DOUBLE BRIDGES ROAD PATHWAY, MUDDY NECK TO NEPTUNE DRIVE

CONTRACT NUMBER: T201769009
FEDERAL AID PROJECT NUMBER: CMAQ-2020(38)
COUNTY: SUSSEX M.R. #: S363

ADDENDUM 2
October 1, 2026

THIS SEAL APPLIES TO THE FOLLOWING SHEETS
CHANGED UNDER ADDENDUM #2:
1, 3, 23, 24, 28, 29, 31, 60

PIER CAP PLAN,
ELEVATION & SECTION

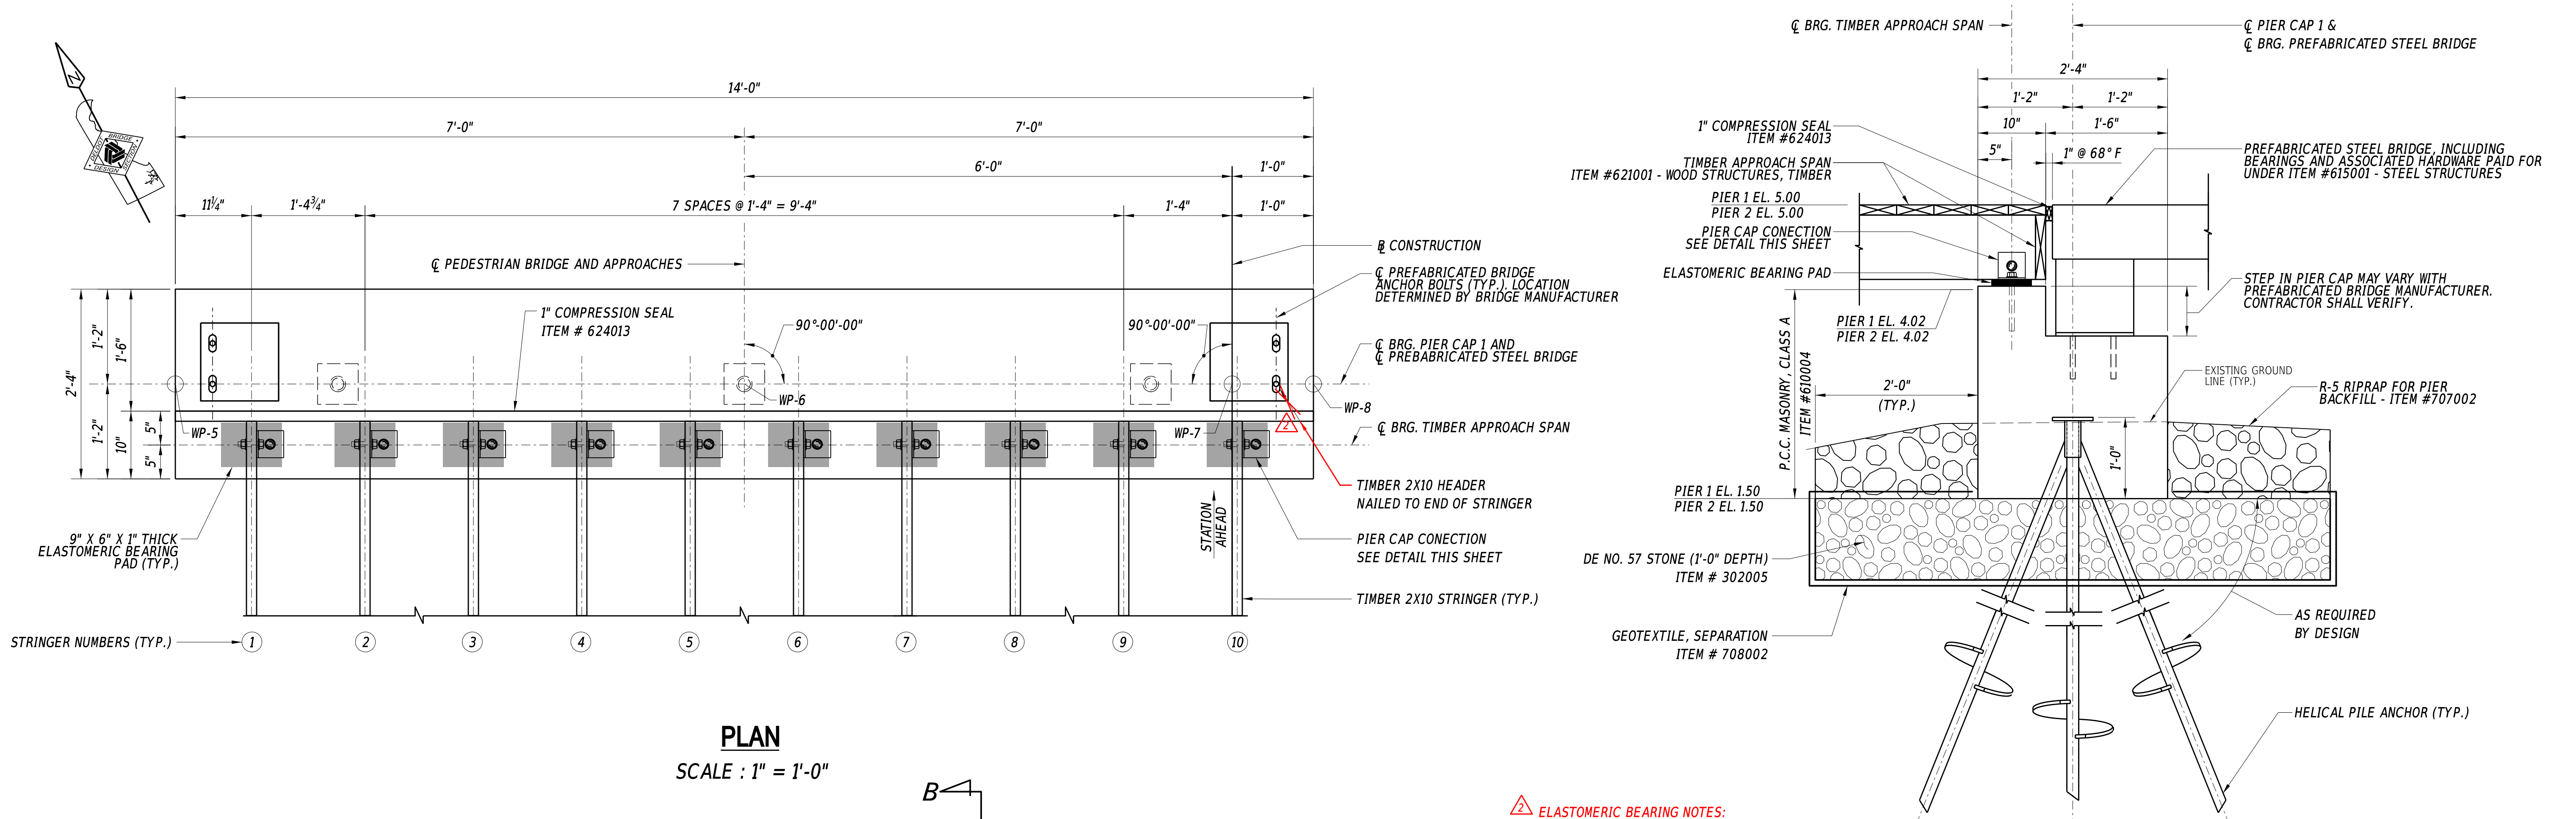
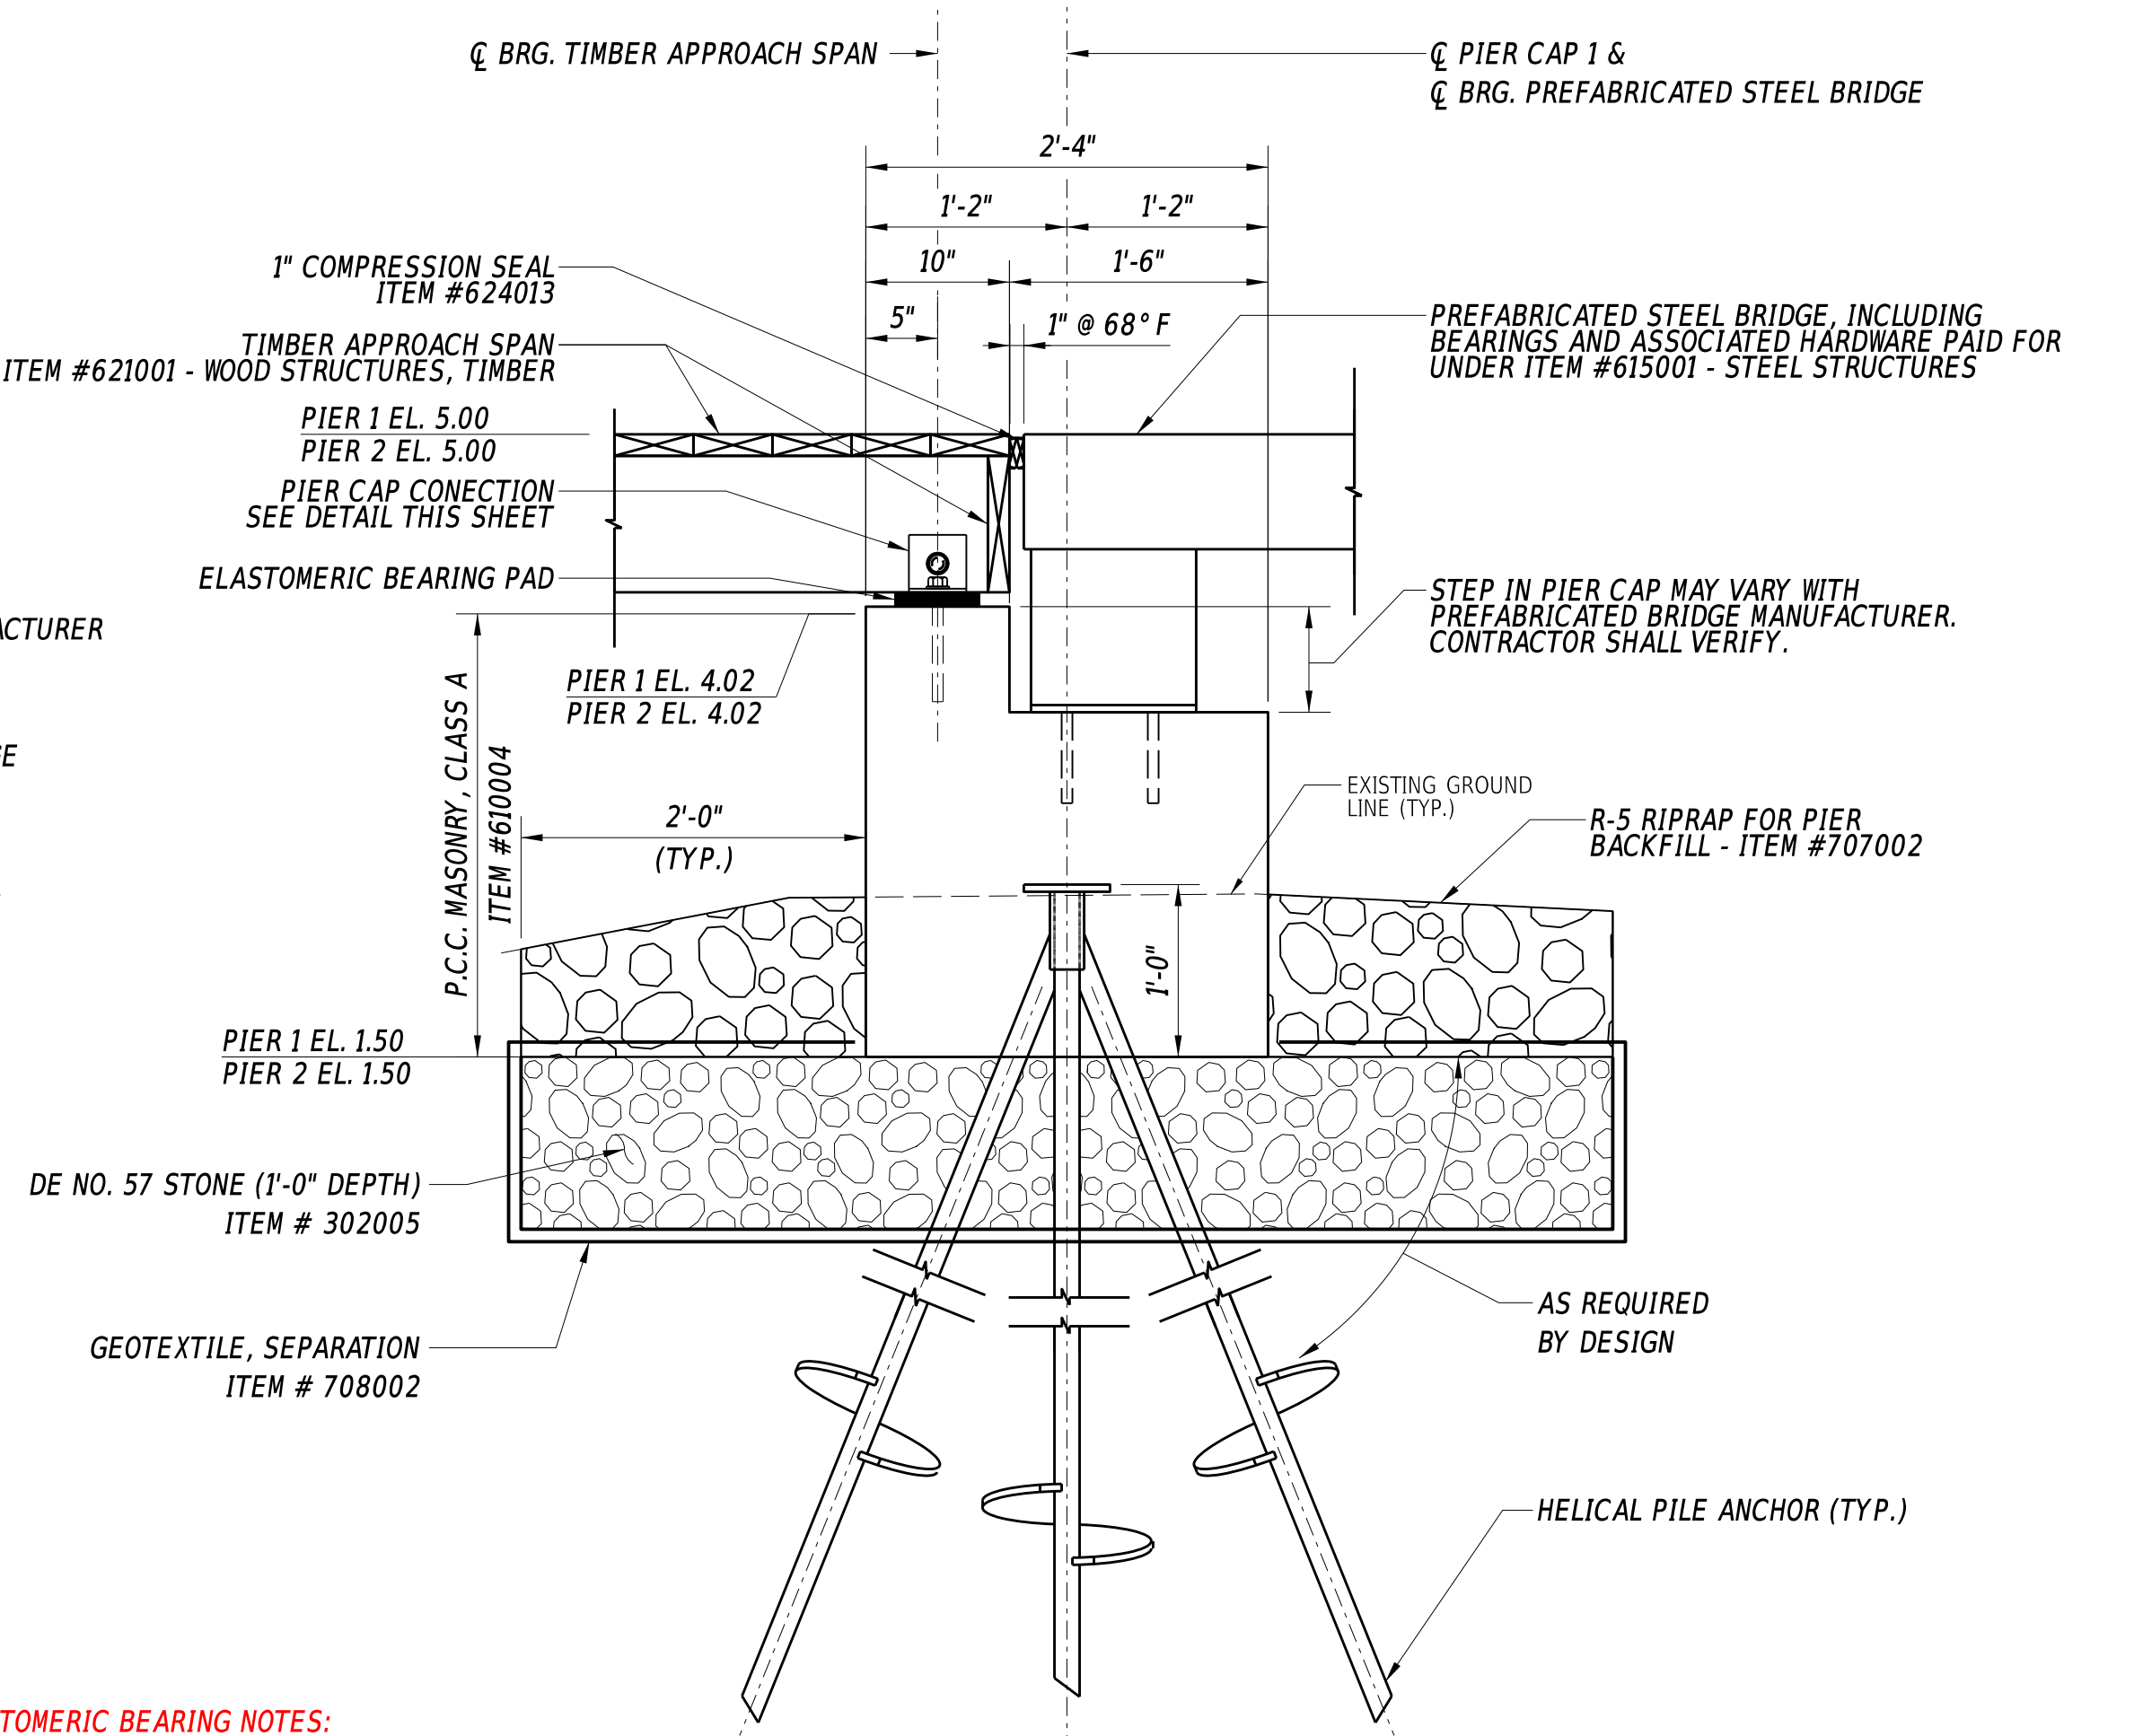
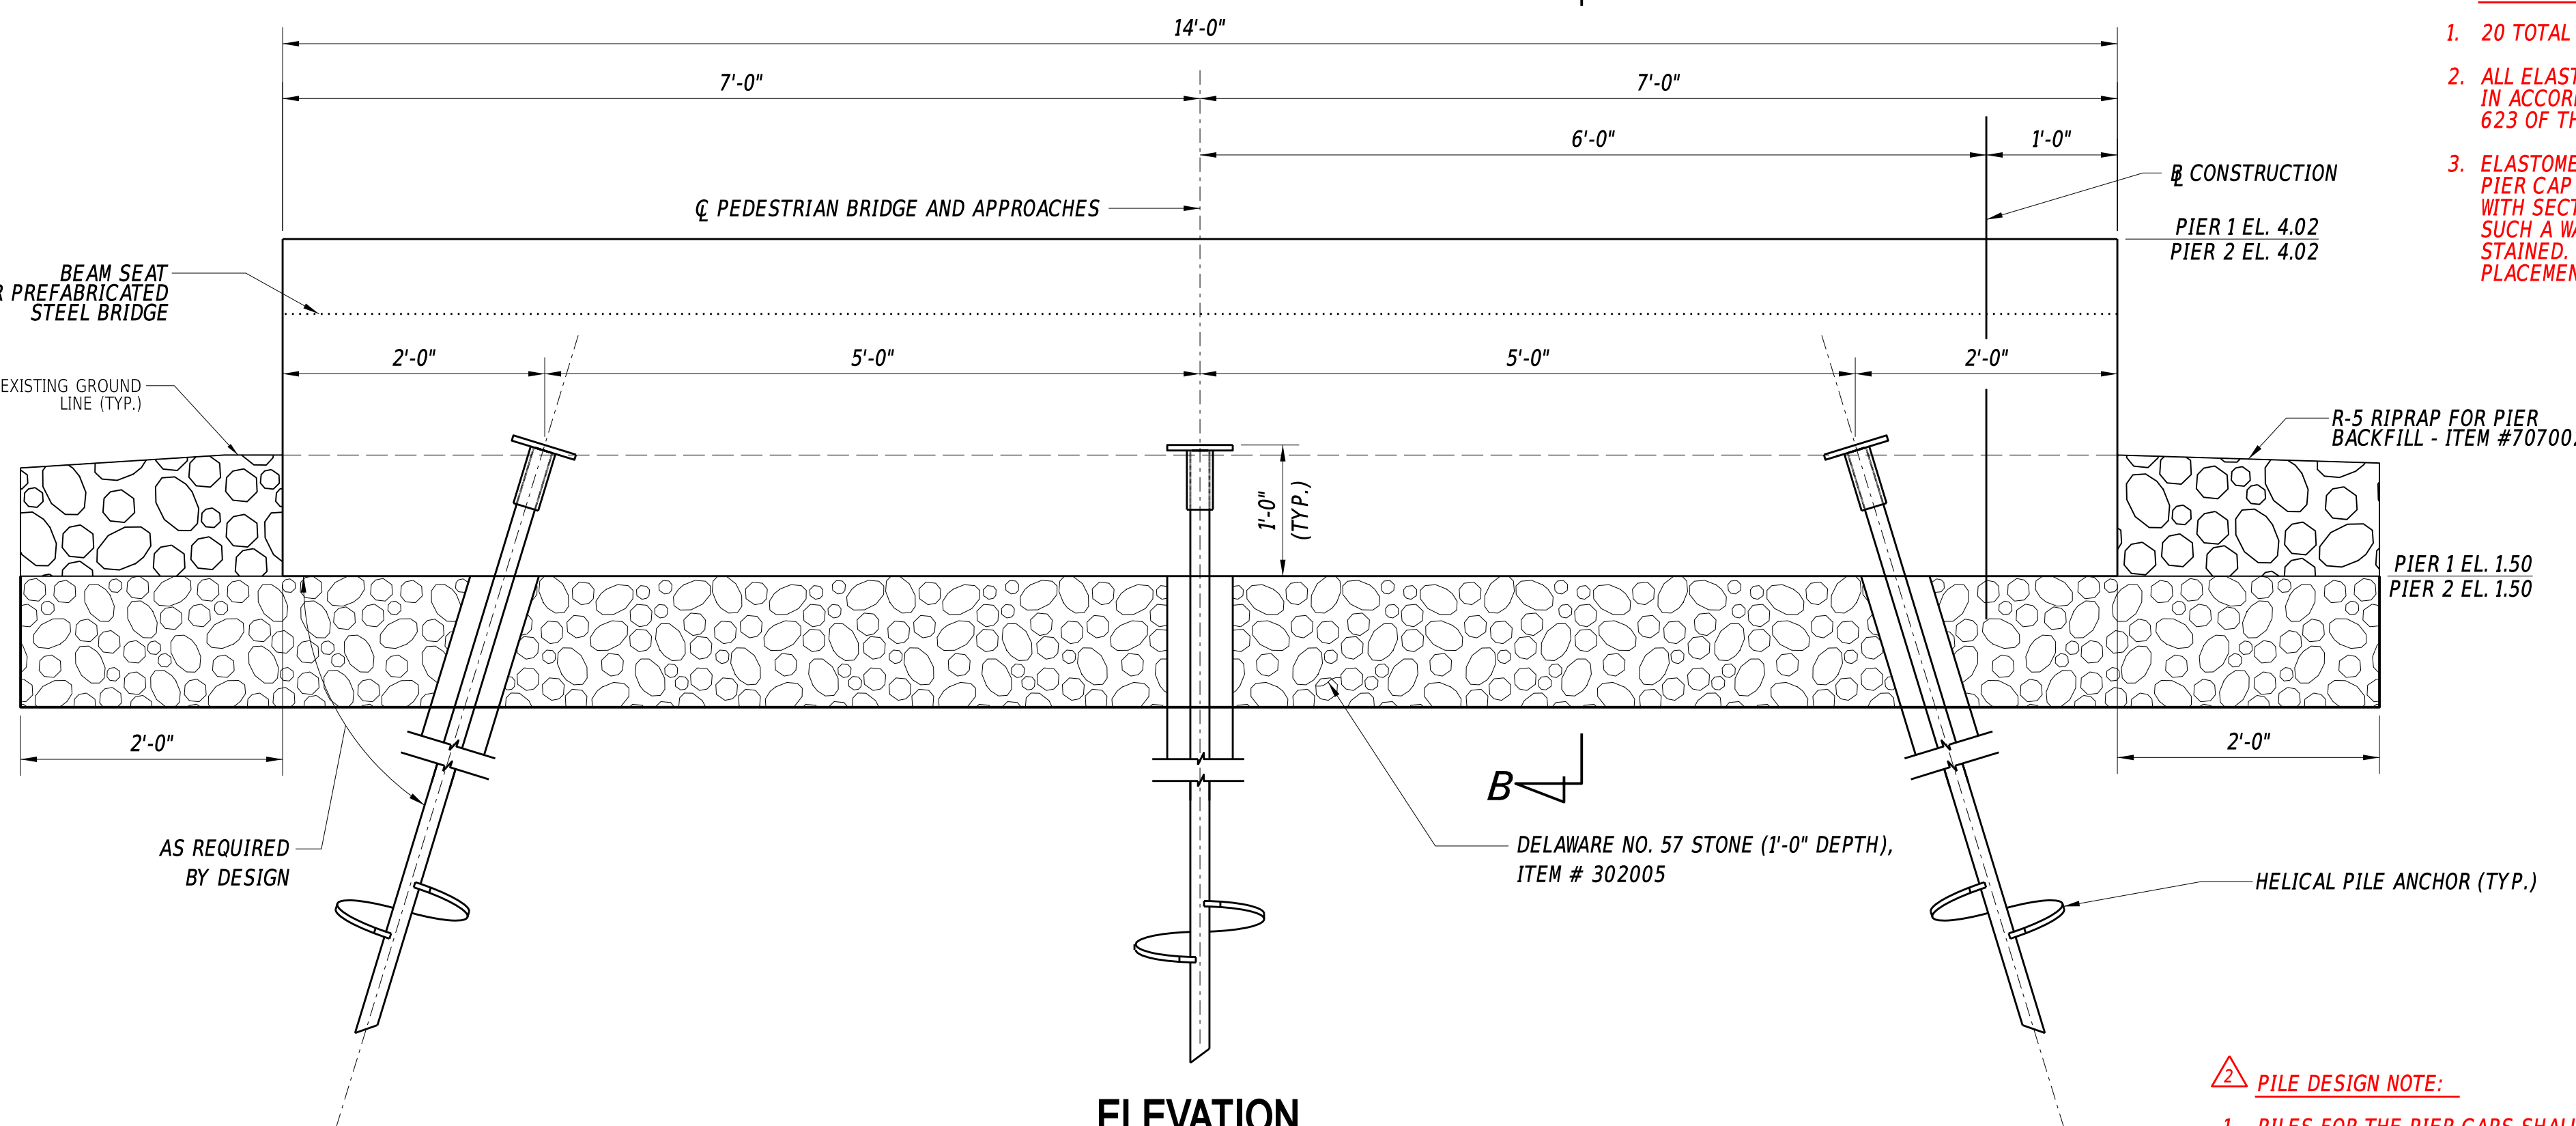
ADDED ELASTOMERIC BEARING NOTES, REVISED PIER CAP CONNECTION DETAIL CALLOUTS, AND ADDED PILE LOADING. BMC 9/28/26

- ELASTOMERIC BEARING NOTES:**
- 20 TOTAL ELASTOMERIC BEARINGS REQUIRED.
 - ALL ELASTOMERIC BEARINGS SHALL BE 50 MIN. DUROMETER IN ACCORDANCE WITH REQUIREMENTS SPECIFIED IN SECTION 623 OF THE STANDARD SPECIFICATIONS.
 - ELASTOMERIC BEARINGS SHALL BE ATTACHED TO THE TOP OF PIER CAP WITH AN APPROVED EPOXY ADHESIVE IN ACCORDANCE WITH SECTION 623.3.D.4 OF THE STANDARD SPECIFICATIONS IN SUCH A WAY THAT VISIBLE CONCRETE SURFACES WILL NOT BE STAINED. ENSURE THE EPOXY ADHESIVE HAS SET PRIOR TO PLACEMENT OF STRINGERS.
